From: Thiel Sydney - Capital Projects on behalf of Thiel Sydney - Capital Projects <SydneyT@ckschools.org>
To: licensing@ahbl.com; Eatch Beck - Capital Projects; Nick Rheaume
Cc: Johnny Hong; Richard Wilson (rwilson@integrusarch.com); Mike Hager; Craig Skipton
Subject: RE: Soule Drainage Pipe
Date: Thursday, January 3, 2019 3:47:52 PM
Attachments: image001.png

Mike and I field reviewed the Soule property to the north of the tennis courts. We observed a 4' drain pipe from the property outletting onto the school district property. It is most likely the roof drainage. This pipe was not identified in the design survey. The survey contours and spot elevations do not pick up the elevation at the low spot in the Soule property back yard near their fence. It is lower than 180.

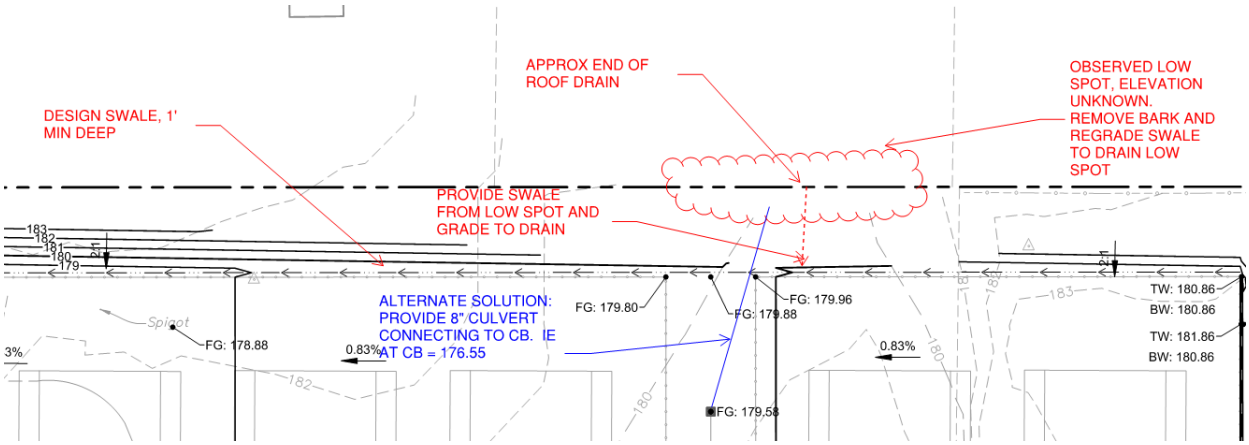
The design intent shown on the drawings is to provide a swale along the north edge of the tennis courts. The V-ditch should be a minimum of 1 foot deep and slope to the west, eventually outletting into the ditch along Frontier. I see two possible solutions:

Option 1. Establish the ditch as shown below in red. Removing bark and regrading is necessary to provide the ditch 1 foot deep and maintain a slope of .83% to the west. The elevation of the low spot should be obtained as well as the outlet end of the roof drain pipe to confirm this depth of swale is adequate.

Option 2. Provide a 8" culvert from the low spot at the north property line and connect to the tennis court CB. Repair HMA paving.

Thank you, Doreen.
My preference is Option 1, simply to avoid rework of finished surface at the tennis court alley.
My current opinion is that the majority of this work is corrective action, rather than a change directive. The possible exception being the small length of regrading from the Soule's outlet pipe to the swale. Do you agree?
